8XC196NP

SPECIFICATION UPDATE

Release Date: September, 1996

Order Number 272838-002

004. *Indirect Addressing with Autoincrement*

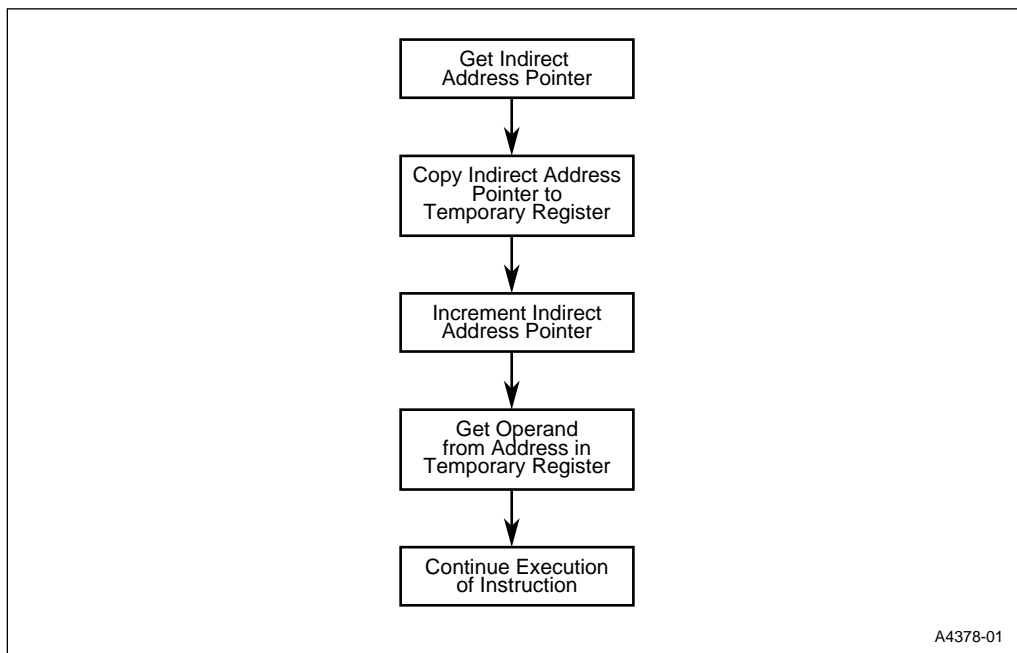
PROBLEM: For indirect addressing with autoincrement, a pointer that points to itself results in an access to the incremented pointer address rather than the original pointer address.

The CPU stores the pointer's value in a temporary register, increments the pointer, then accesses the operand at the address contained in the temporary register, as shown in this flowchart.

Therefore, if the pointer points to itself, the CPU accesses the operand at the incremented address contained in the pointer.

001. *READY Timing Diagram Correction - 8XC196NP Data Sheet*

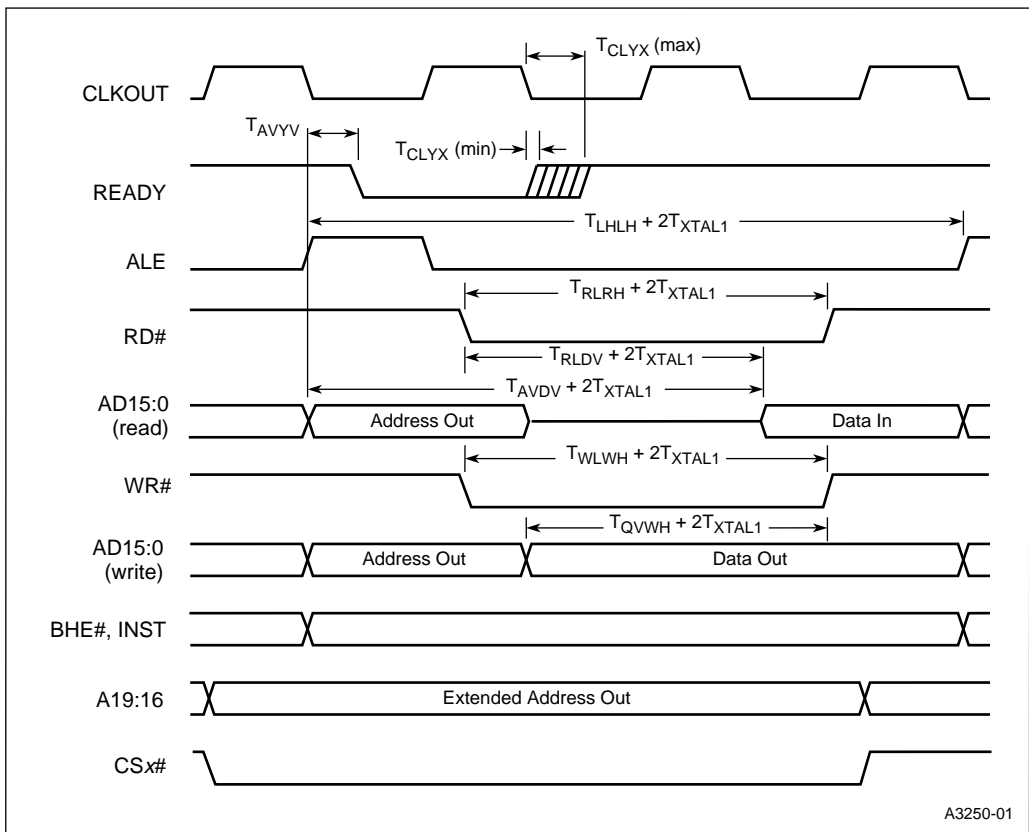
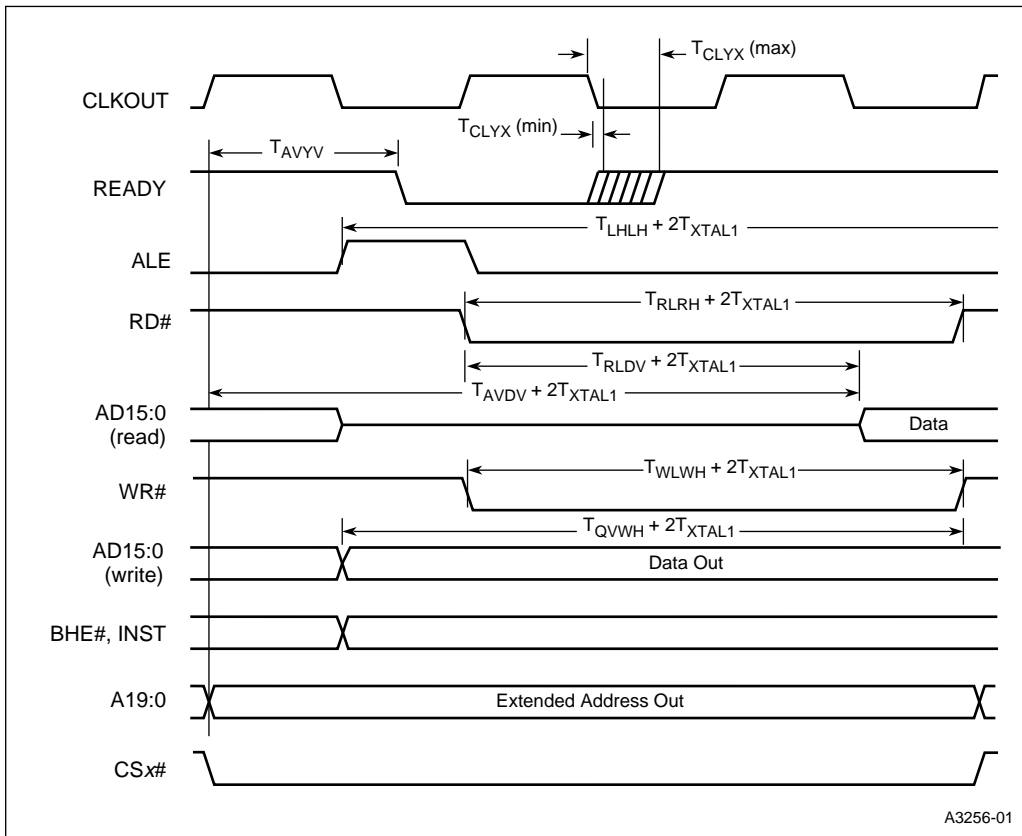
The value $2T_{XTAL1}$ was incorrectly shown as T_{XTAL1} in the READY timing diagrams. The following two figures replace Figure 7 and Figure 9 in the datasheet.

Figure 7. READY Timing Diagram (Multiplexed Bus Mode)

Figure 9. READY Timing Diagram (Demultiplexed Bus Mode)
